**Service Contract No. NDO 04/2019**  
**Environmental Team for Environmental Monitoring and Audit Works in Construction Phase for the First Phase Development of Kwu Tung North and Fanling North New Development Areas**

**Environmental Permit No. EP-469/2013: Submission of the Landscape Plan for Sewage Pumping Station D1-3 (Condition 2.6)**

**Submission of Landscape Plan for Sewage Pumping Station D1-3 (EP-469/2013)**

(Ref. EP/DP5/D1-3/2022-01A)

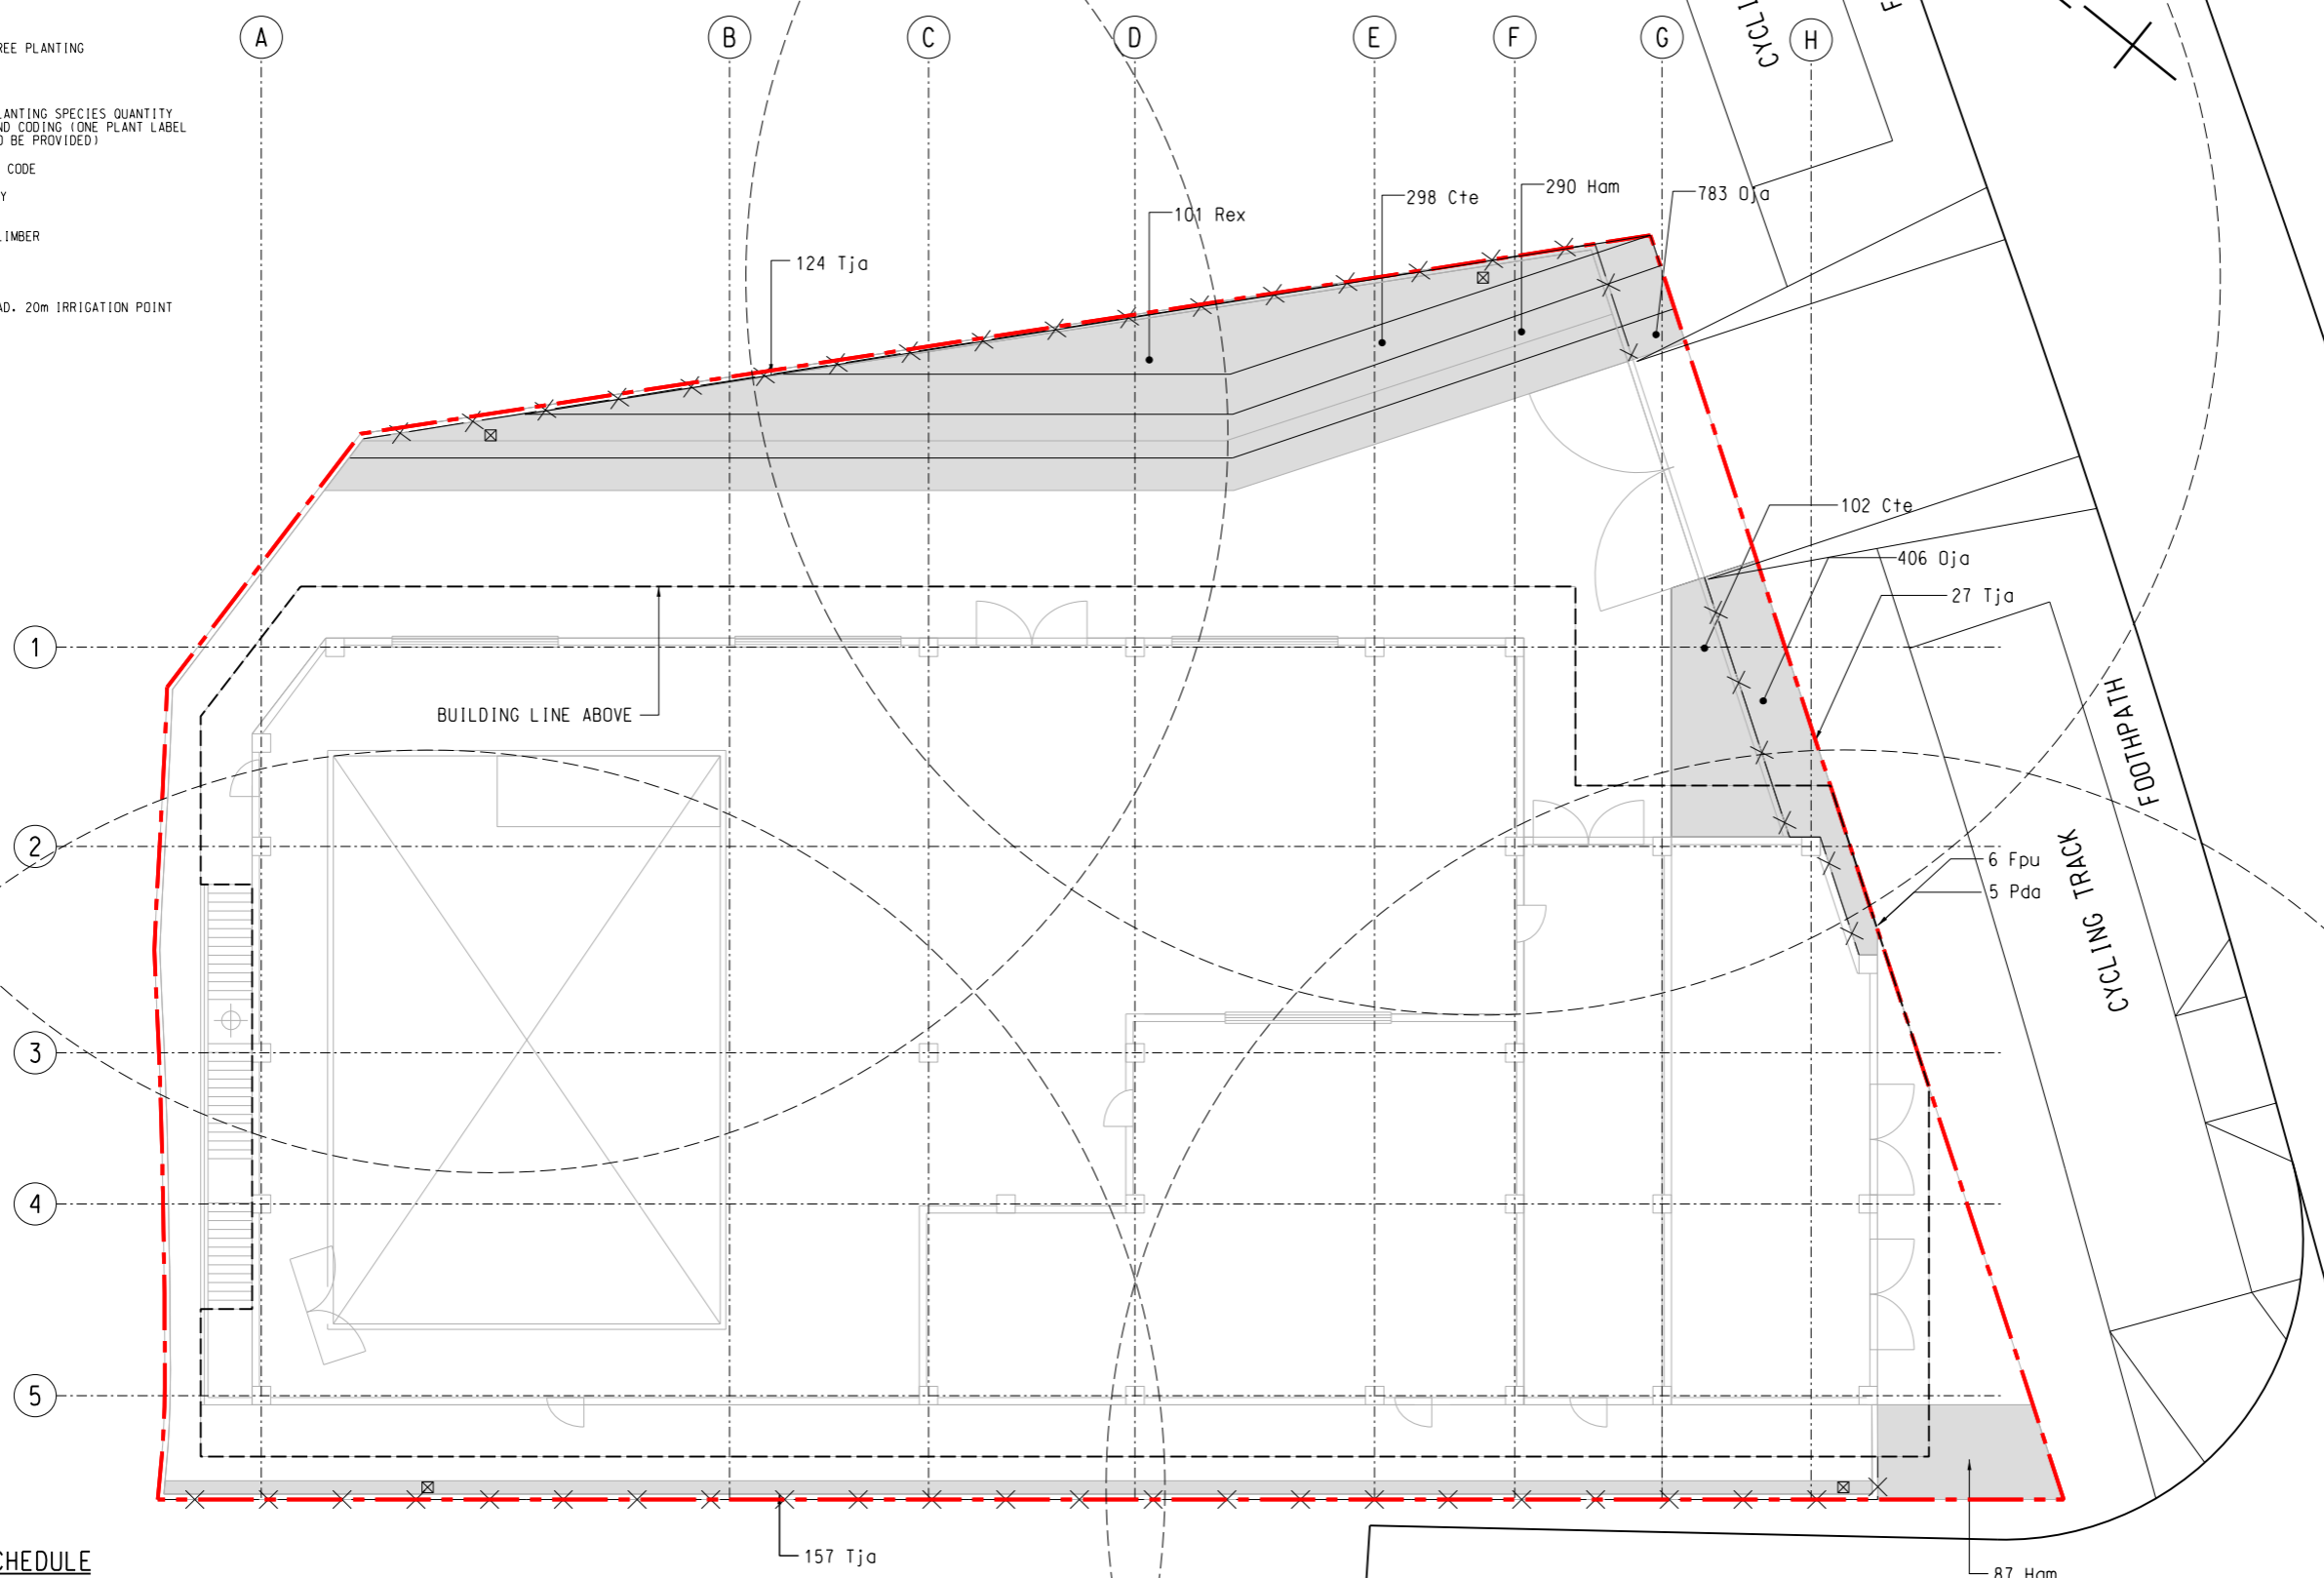
<p>(vi) On “Proposed Species – Shrubs and Groundcover”, site boundary is missing on the plan.</p>	<p>Noted and the site boundary is added for ease of reference.</p>

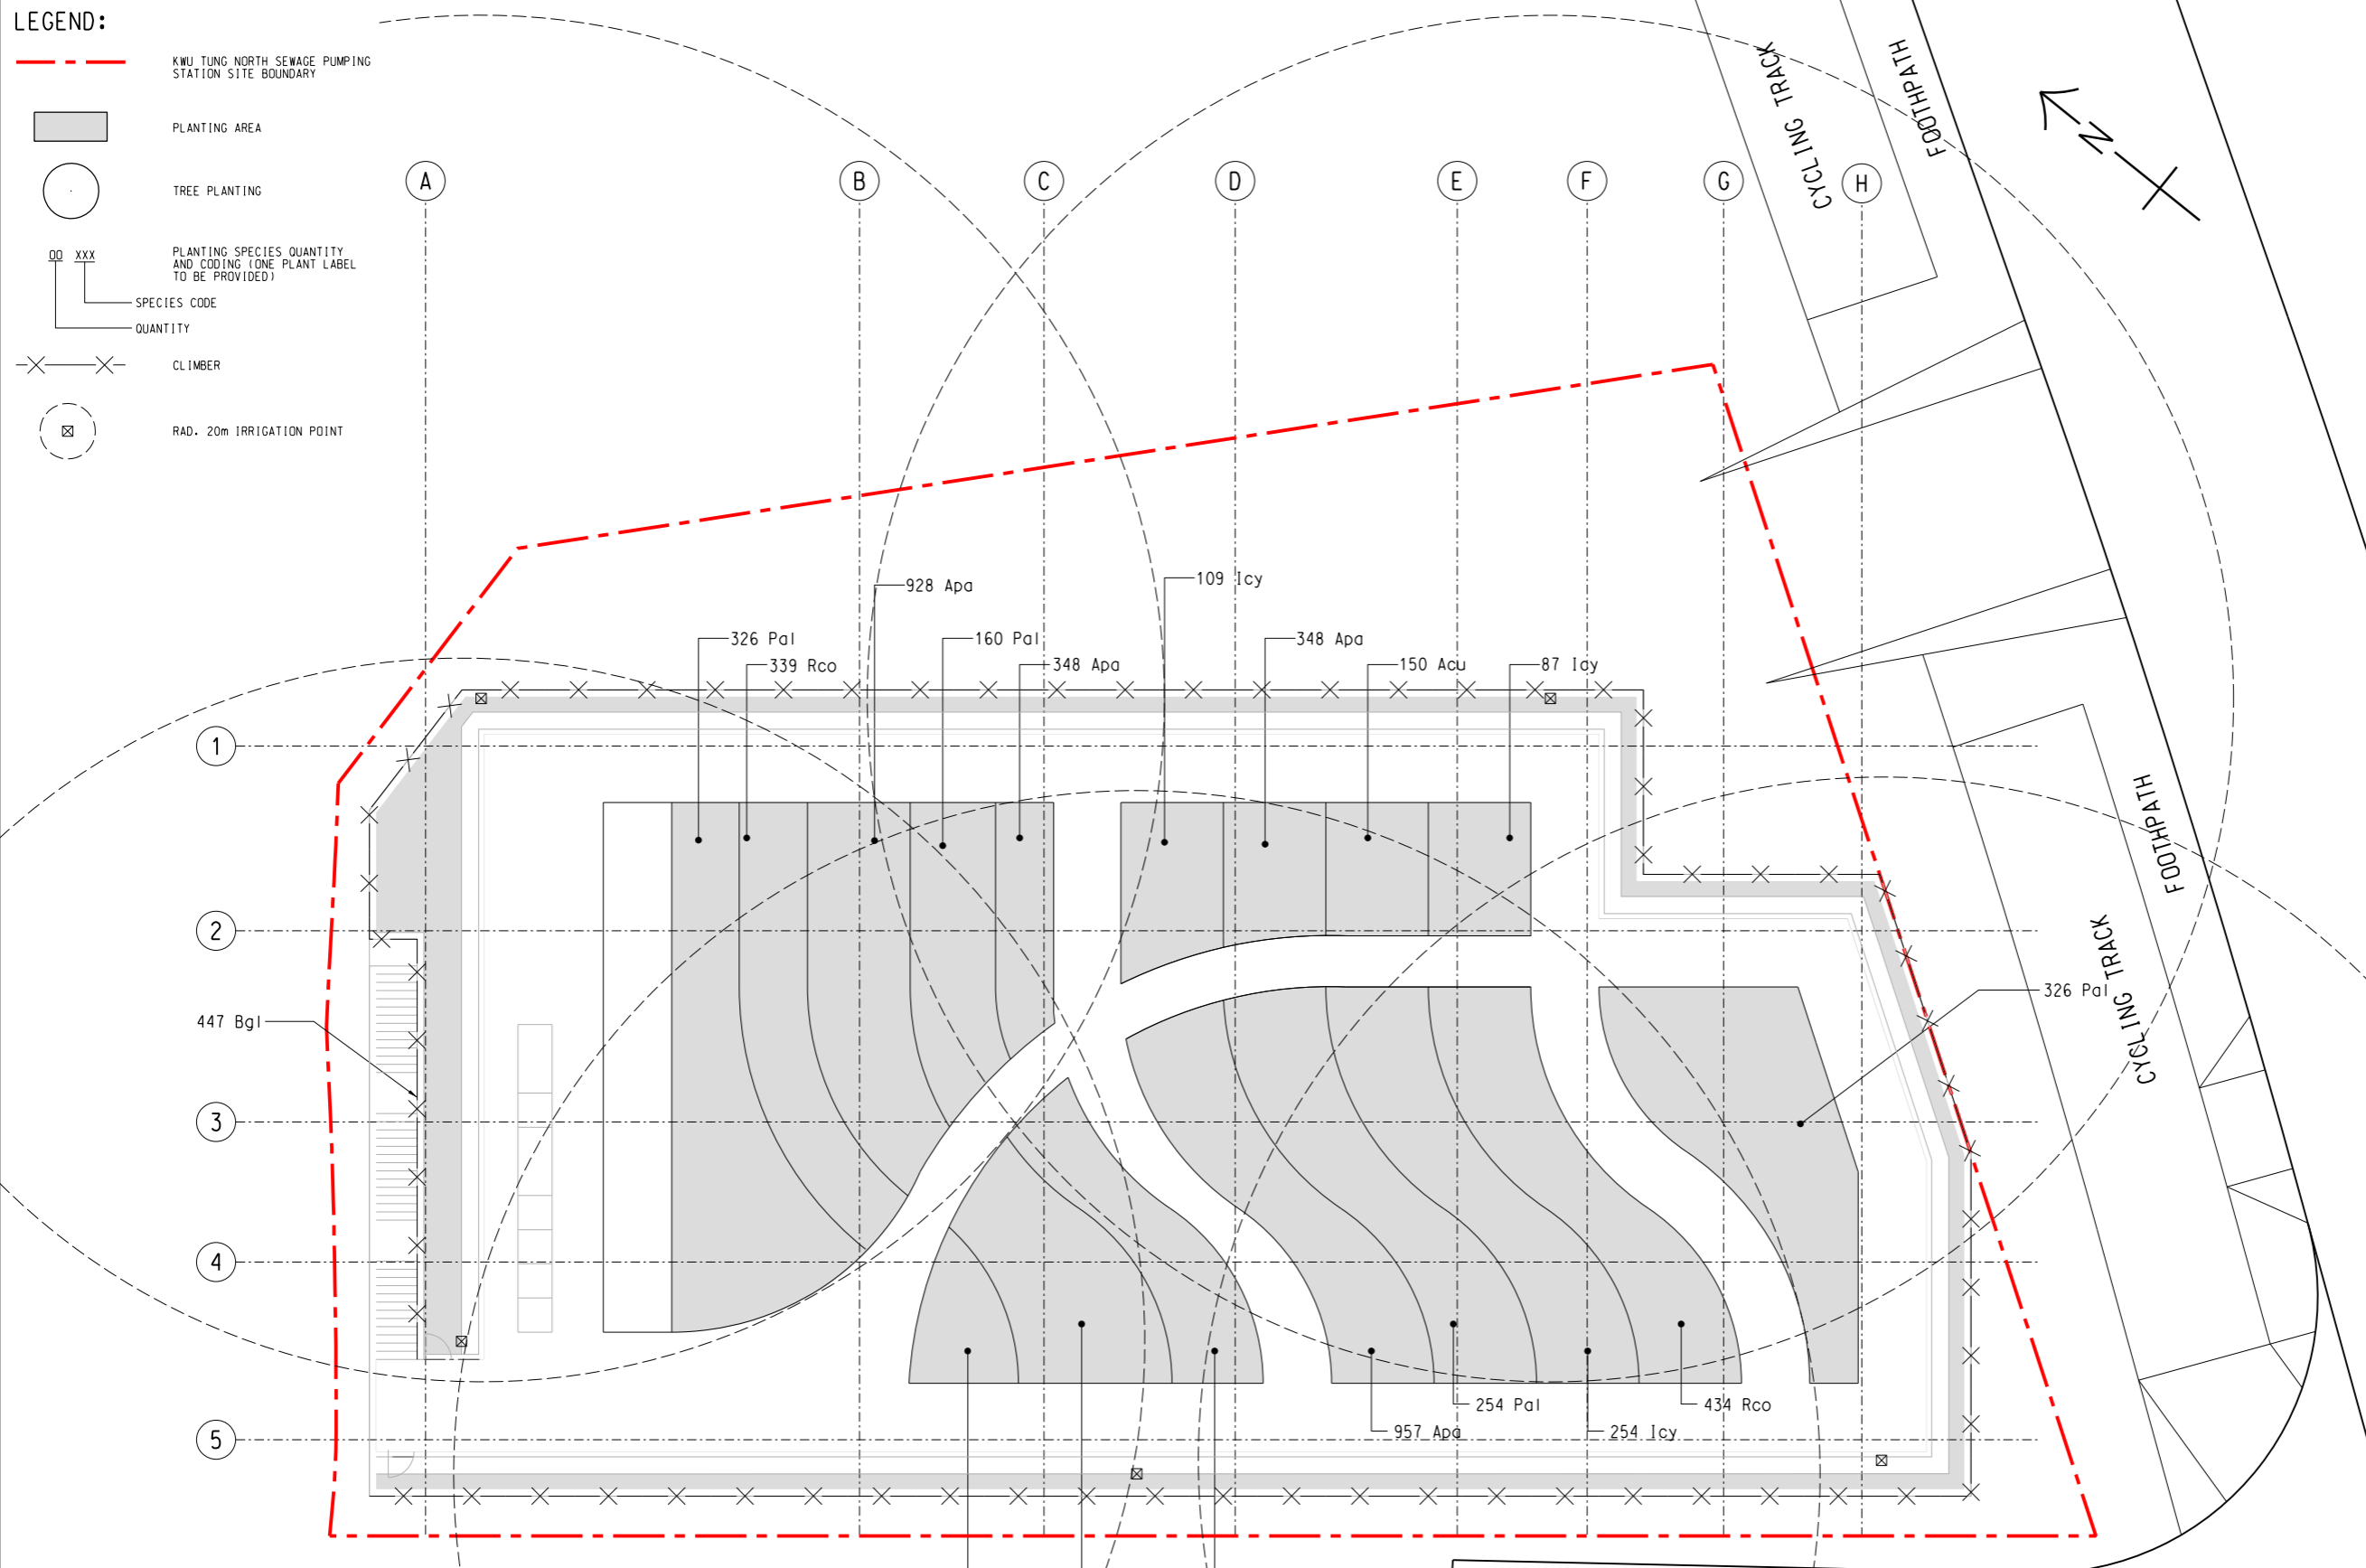
<p>(vii) On “Proposed Species on Roof”, proposed plant species for one of the planting strips is missing.</p>	<p>The concerned plant species for the planting strip is <i>Bauhinia glauca</i> as a hanging plant for the building façade. The selected planting species is added in the same drawing for ease of reference.</p>
<p>(viii) On “Proposed Species – Climbers and Creepers”, <i>Trachelospermum jasminoides</i> 絡石 is proposed at hard-paved areas and not tally with the species in para 5.9.1 (i.e. <i>Parthenocissus tricuspidata</i>). Besides, the vertical climbing plants (i.e. shown on the East Elevation) at the SE besides the main gate is missing and the area concerned is hard-paved on this plan.</p>	<p>There are four proposed species for climbers and creepers adopted for the SPS design. They are including <i>Bauhinia glauca</i> 粉葉羊蹄甲, <i>Parthenocissus tricuspidata</i> 爬牆虎, <i>Ficus pumila</i> 薜荔 and <i>Trachelospermum jasminoides</i> 絡石. The composition of using these species in SPS are listed as follows,</p> <ul style="list-style-type: none"> <li>- Hanging plant on roof at canopy edge adopts <i>Bauhinia glauca</i>,</li> <li>- Identified green visual vertical climbing plants at southern east adopts <i>Parthenocissus tricuspidata</i> and <i>Ficus pumila</i>,</li> <li>- Recycle wood composite fence wall with climbing plants adopts <i>Trachelospermum jasminoides</i></li> </ul> <p>In align with the above principles on climber design in SPS, Section 4.1.4, Section 5.9.1 and Section 5.11.1 have been revised accordingly.</p>
